Ser. No.: 09/526,442

Our ref. No.: 10442-5 US JA/AD

- R E M A R K S -

Figure 4

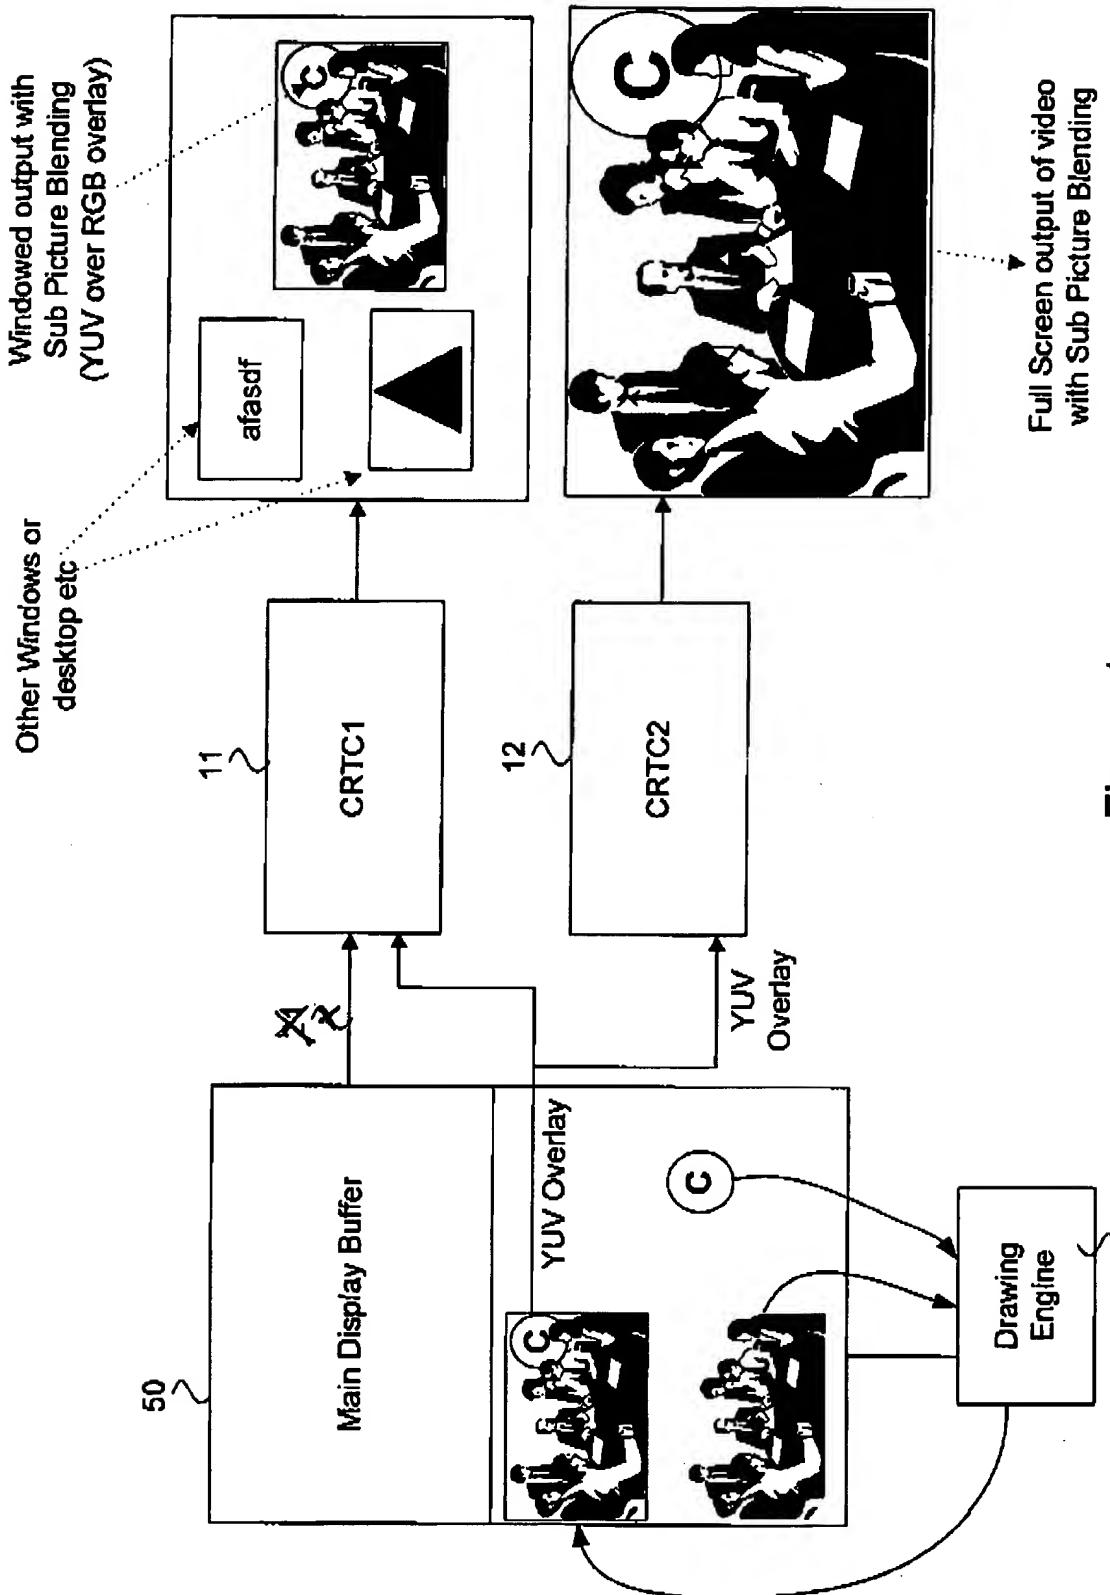
A marked-up copy of Figure 4 is submitted herewith for the Examiner's approval.

The Applicant has amended the application in order to comply with 37 CFR 1.84(p)(5). Reference numerals "26", "28", "30", "31", "32", and "36" in Figure 1 were added to the specification to include a reference in the description for each reference sign in the figures. Support for this amendment is found in figure 1 of the present application as well as at page 10, lines 8-9 of the 09/526,440 application, incorporated by reference in the present application. Reference numeral "21" from figure 4 has been removed.

The Examiner has objected to figure 4 as being of poor quality. In view of the current proposed amendment to figure 4, Applicant will wait for approval before submitting a high quality figure.

*Approved
5/19/03*
